**TOWN OF NEWBURGH  
PLANNING BOARD  
TECHNICAL REVIEW COMMENTS**

**PROJECT: DORRMANN SUBDIVISION**  
**PROJECT NO.: 21-03**  
**PROJECT LOCATION: SECTION 1, BLOCK 1, LOT 93**  
**REVIEW DATE: 28 MAY 2021**  
**MEETING DATE: 3 JUNE 2021**  
**PROJECT REPRESENTATIVE: TALCOTT ENGINEERING**

Re: Resubmission letter  
Town Project No. 2021-03  
Dorrmann Subdivision  
Weaver Road  
SBL: 1-1-93  
AR Zone  
Job No. 20177-RDR

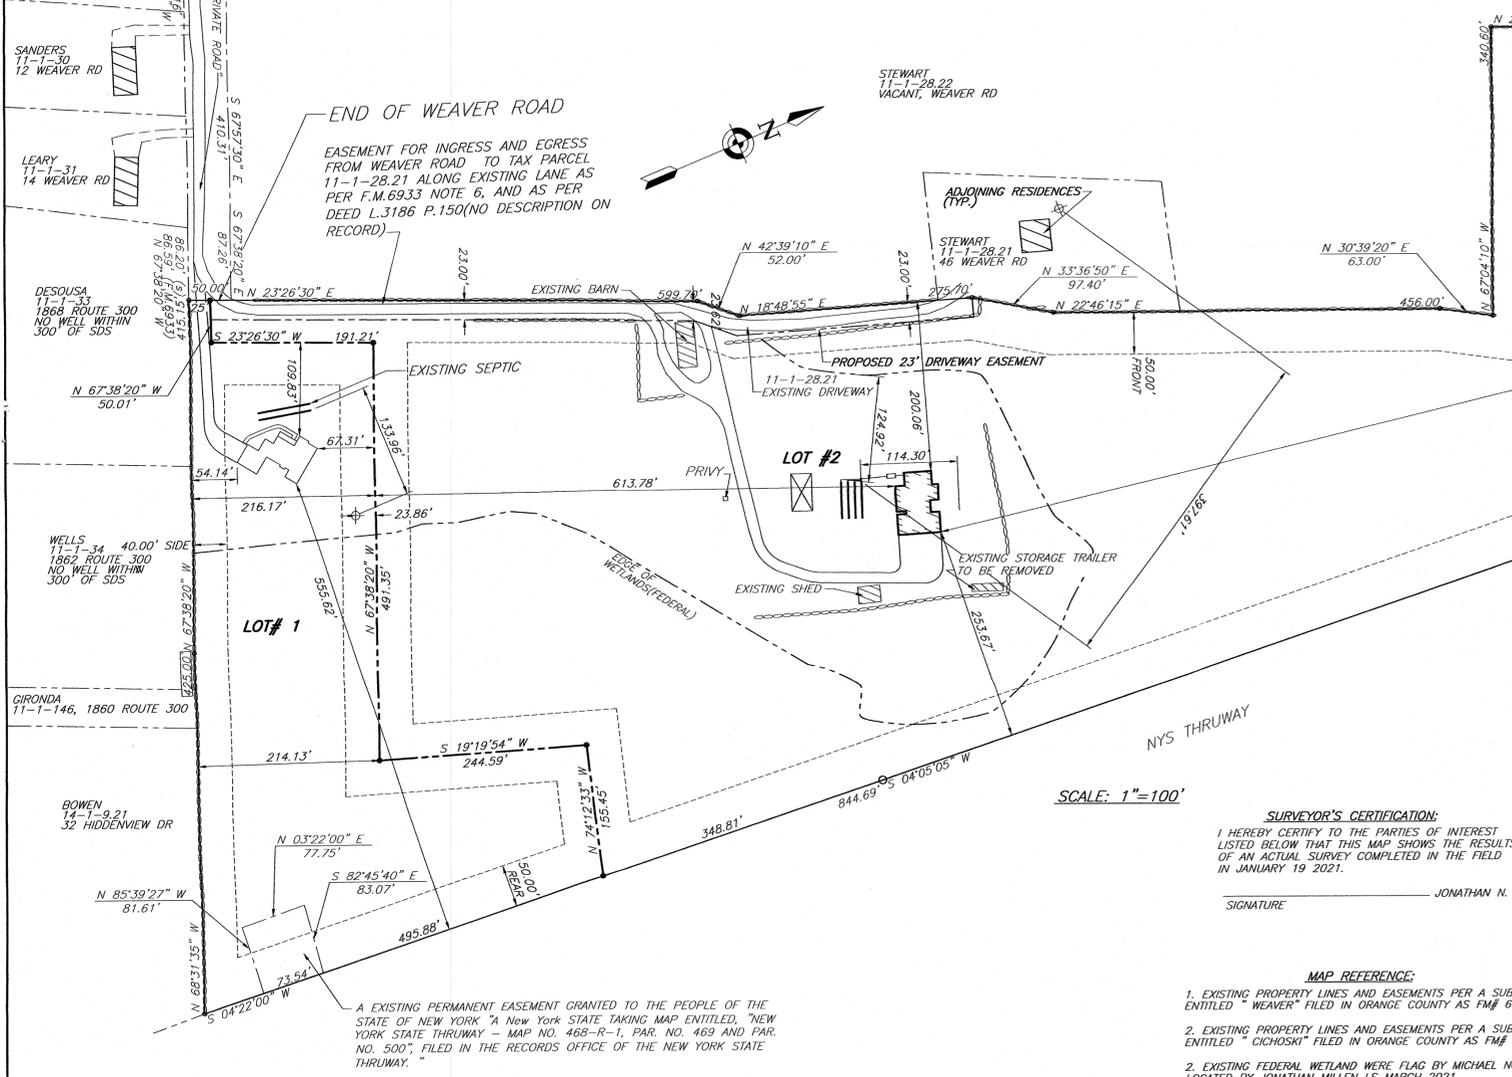
1. Information pertaining to the easement has been submitted to the Planning Board Attorney for review.
2. This office previously requested the well be depicted on the large plan as well as the blow up plan depicted.

- 1) Surveyor will provide by Planning Board Meeting
- 2) 25' frontage is labeled for Lot 1.
- 3) Storage trailer is noted "to be removed."
- 4) Wells and septic are shown as requested.
- 5) Wetland is now delineated and surveyed.
- 6) I will address at the Planning Board Meeting.
- 7) A waiver on topography is requested.
- 8) (No response required)
- 9) (No response required)
